SUBJECT: CHANGE OF WIND GARDEN AND FRONTEER TURBINE LOCATIONS, FRONTEER AND WIND GARDEN

Wind Garden and Frontier - Optimised layout

Figure 1 Illustration of initial and amended turbine locations (2020 vs 2022)

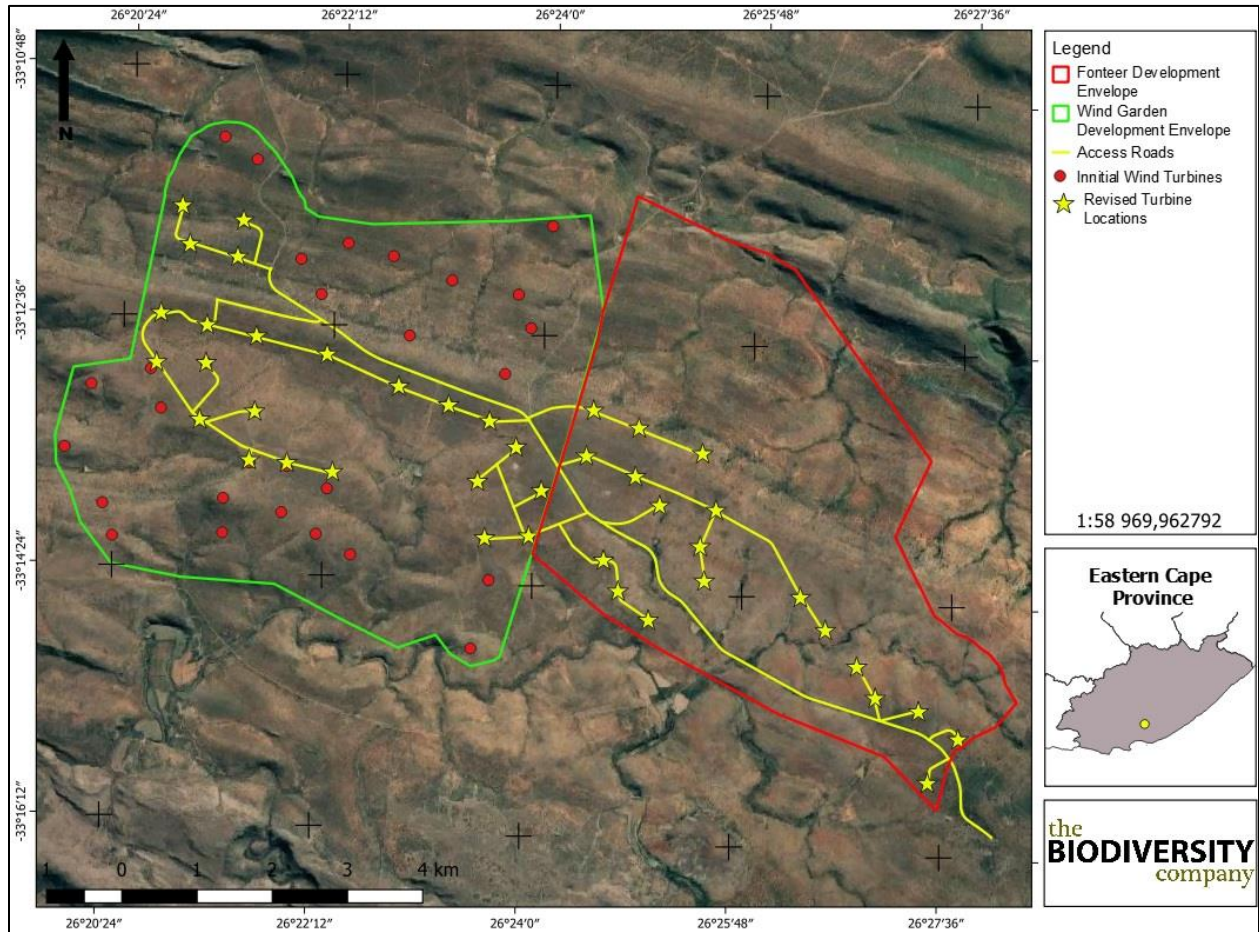
The Biodiversity Company was requested to comment on the affect that a change of wind turbine locations will have on the outcomes of existing agricultural compliance statements completed in 2020 for the Wind Garden and Fronteer developments. Figure 1 illustrates the comparison between those wind turbines initially proposed versus what is currently proposed (amended locations). A final optimised layout of the wind farms has been produced which has reduced the number of turbines from 38 down to 19 for Fronteer and 47 down to 23 for Wind Garden. The turbines proposed to be used will also be slightly smaller having a hub height of 115m instead of the originally proposed 120m. The rotor diameter will remain at 150m, but with a reduction in blade tip height from 200m to 190m. The change would also necessarily result in a reduction in the extent of turbine access roads and associated infrastructure. The said revision to the layout was implemented in order to address outstanding concerns from I&APs.

The majority of the initial proposed wind turbine locations were located in Very Low-Low sensitivity with only a few turbines located in Moderate sensitivity. In the optimised layout majority of the turbines that were removed from the project were located in areas of Very-Low Sensitivity and majority of the turbines left (i.e. forming part of the optimised layout) are located in Moderate sensitivity. No new sensitivities were triggered (see Figure 2). Regardless of the fact that higher sensitivity land potential resources will be affected than initially thought, it is the specialist's opinion that the final impact statement and impact ratings will not change. The impact statement is as follows;

This impact statement is still applicable, due to the fact that no "High" sensitivity resources will be impacted by the optimised layout. The change in wind turbine locations will therefore not affect the outcome of the project in relation to impacts to land potential resources and may therefore still be favourably considered.

Figure 2 Sensitivities associated with the Frontier and Wind Garden development envelopes

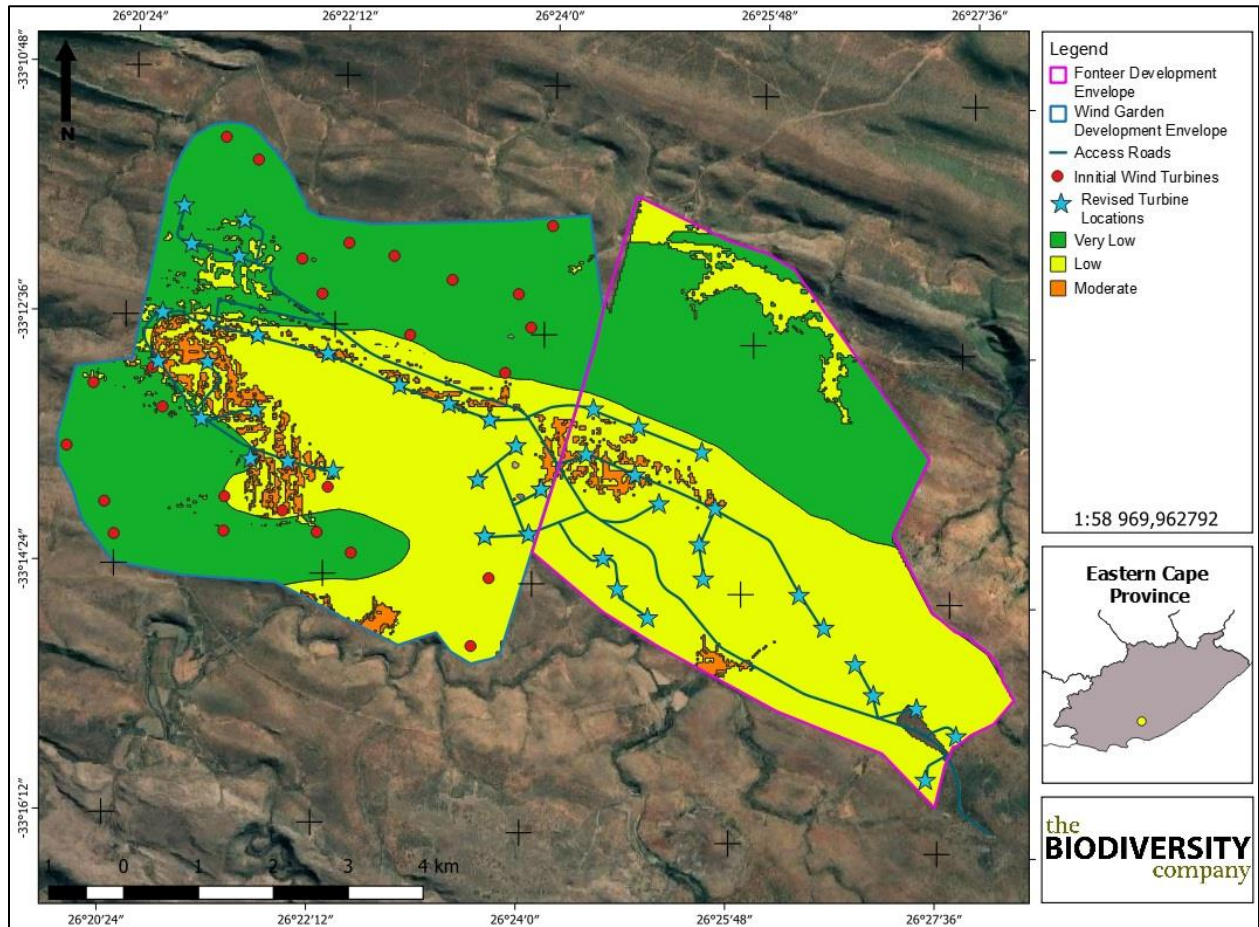
It is the specialist's opinion that the baseline findings concur with the land capabilities identified by means of the DAFF (2017) desktop findings in regard to land capability sensitivities. No "High" land capability sensitivities were identified within proximity to any of the proposed activities. Considering the lack of sensitivity and the measures put in place in regard to stormwater management and erosion control, it is the specialist's opinion that all activities will have an acceptable impact on agricultural productivity. Furthermore, no measures in regard to moving components in their micro-setting were required to avoid or minimise fragmentation and disturbances of agricultural activities.
